Work Order ID 91765

Item Name: Crosstube Turning Detail

DART AEROSPACE LTD	Work Order:	91765
Description: Crosstube Assembly (412 High Aft)	Part Number:	D412-664-243
Inspection Dwg: D412-664-243 Rev: E		Page 1 of 2

DRAWING NO. D412-664-243	TITLE CROSSTUBE ASSEMBLY (412 HI AFT)	REV. E	DART AEROSPACE LTD ENGINEERING ORDER		D.E.O. NO. D412-664-243-E-1	SHEET NO. SHEET 1 OF 2	SCALE NTS
DRAWN	CHECKED <i>MP</i>	MFG. APPR. <i>E</i>	APPROVED <i>MP</i>		DE APPR. <i>MP</i>		
DATE 11.03.31	DATE 11/03/31	DATE 11.03.31	DATE 11/03/31		DATE 11-03-31

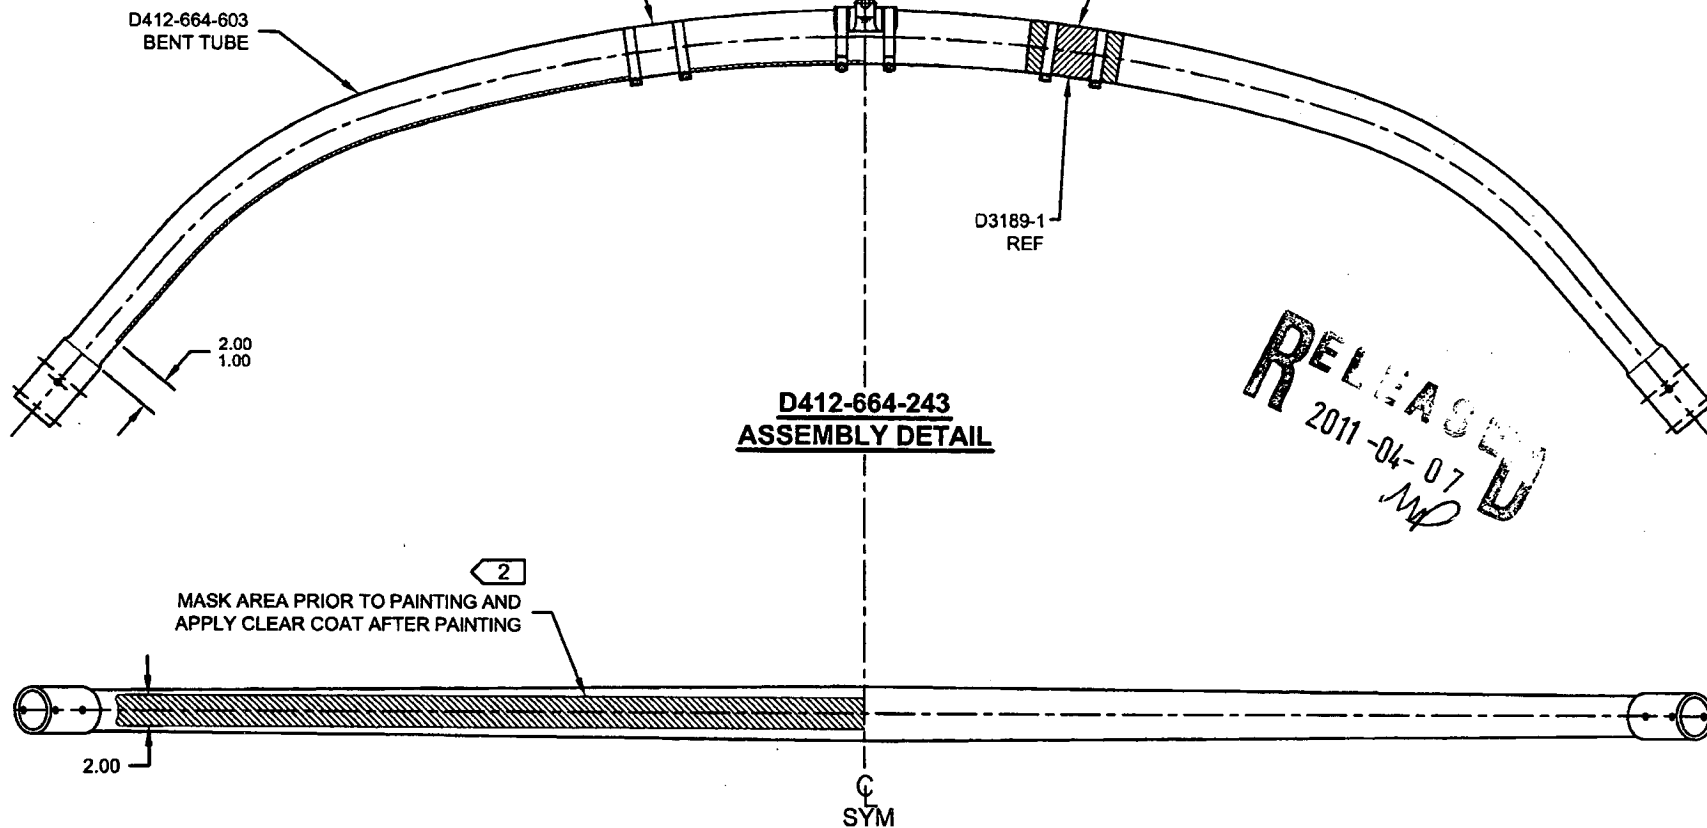
REMOVED ABRASION STRIP IN FAVOR OF A THIN LAYER OF PROSEAL 890.

IS:

D3189-1 CHAFING SHIELD (1, INSTALLED OVER PROSEAL 890)
MS21920-28 CLAMP, 2X
2 PL

WAS:

D2856-600-1009 ABRASION STRIP
D3189-1 CHAFING SHIELD (1, INSTALLED OVER ABRASION STRIP)
MS21920-28 CLAMP, 2X
2 PL

**D412-664-243
ASSEMBLY DETAIL**

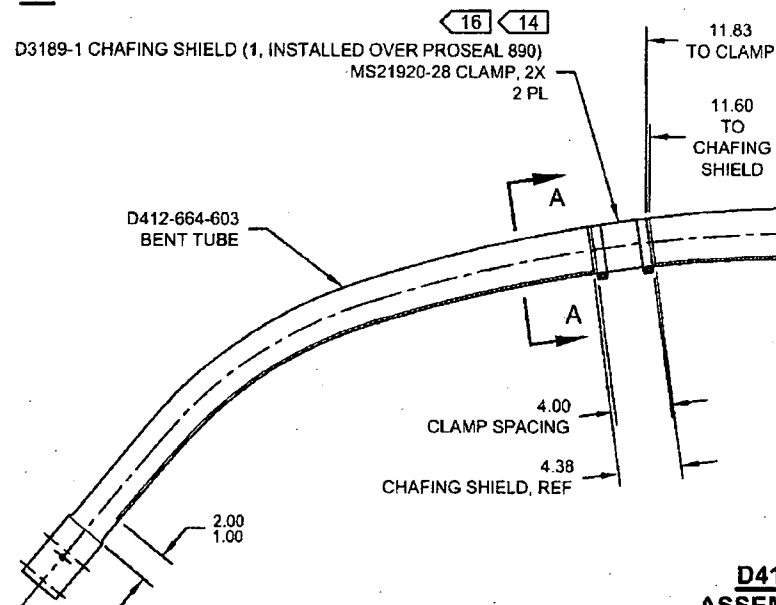
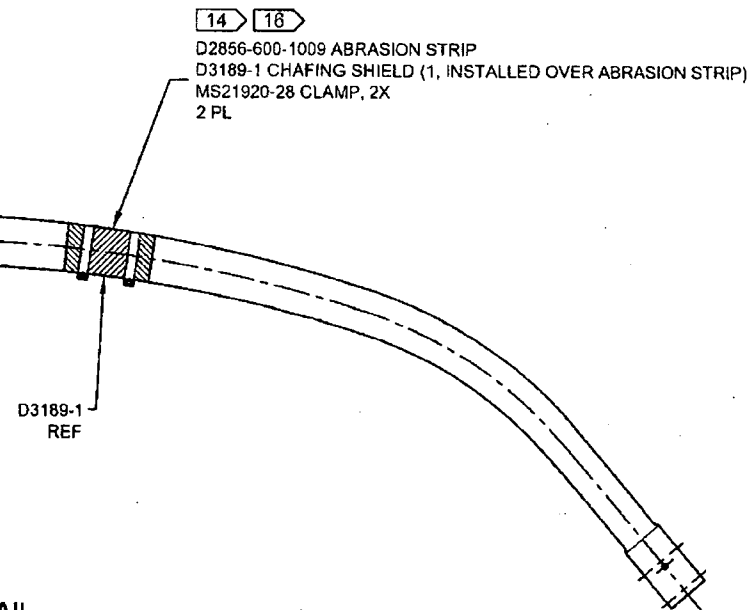
REMOVED ABRASION STRIP IN FAVOR OF A THIN LAYER OF PROSEAL 890. UPDATE INSTALLATION OF CHAFING SHIELDS AND REDUCE TORQUE TO 40-50 IN-LBS. THIS ENGINEERING ORDER SUPERCEDES DEO D412-664-243-E-1.

IS:

WAS:
